ADDENDUM #4

TO: Potential Offerors  
FROM: Cora Shirai, Contract Manager  
RE: Solicitation Addendum #4 to RFP #22-01/Imaging Department Renovation

See G70 Addendum 3 (attached) for KVMH and SMMH Imaging Department Renovations. Changes include adding supports for the chest stands at the x-ray rooms and clarifying the dimming devices for lights.

**KVMH IMAGING DEPARTMENT RENOVATIONS**

DRAWING TITLE  
**LIGHTING PLAN - 2**

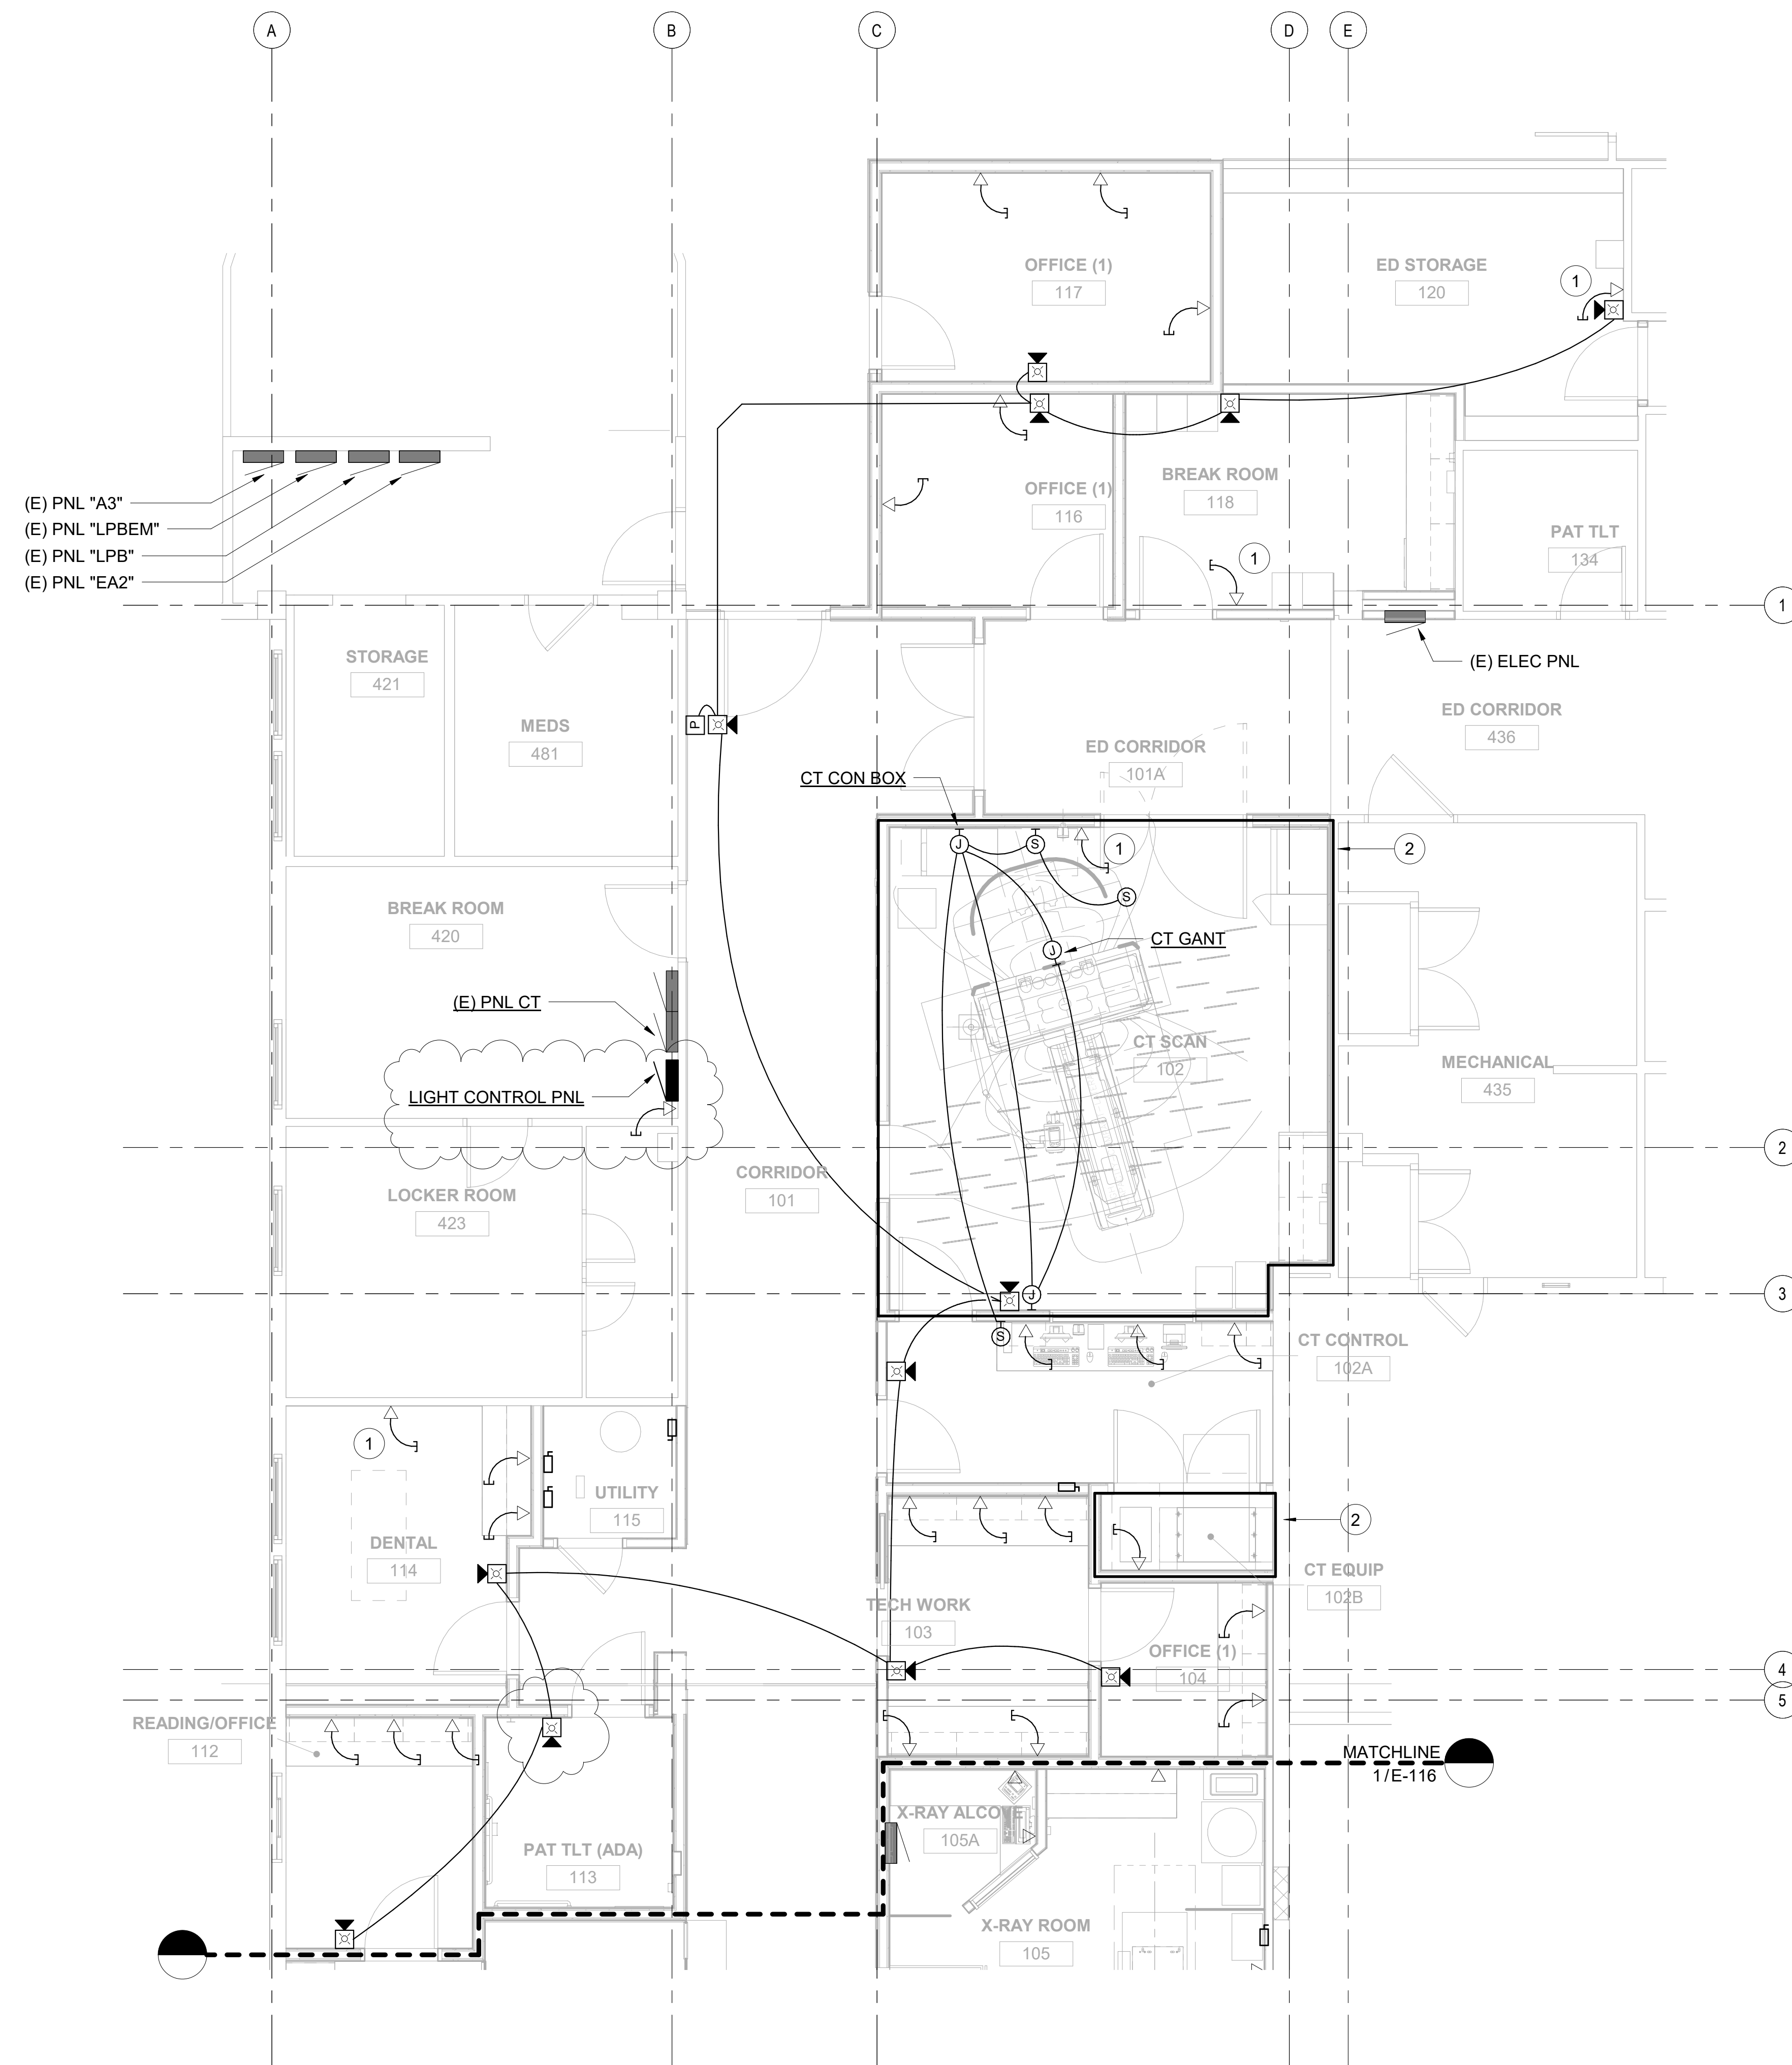
Drawing No.	Delta No.	Description
E-001	3	Added energy code stamp
E-002	3	Added to symbol list
E-113	3	Revised plan
E-114	3	Revised plan
E-115	3	Revised plan
E-116	3	Revised plan
E-402	3	Revised diagram
E-403	3	Added sheet
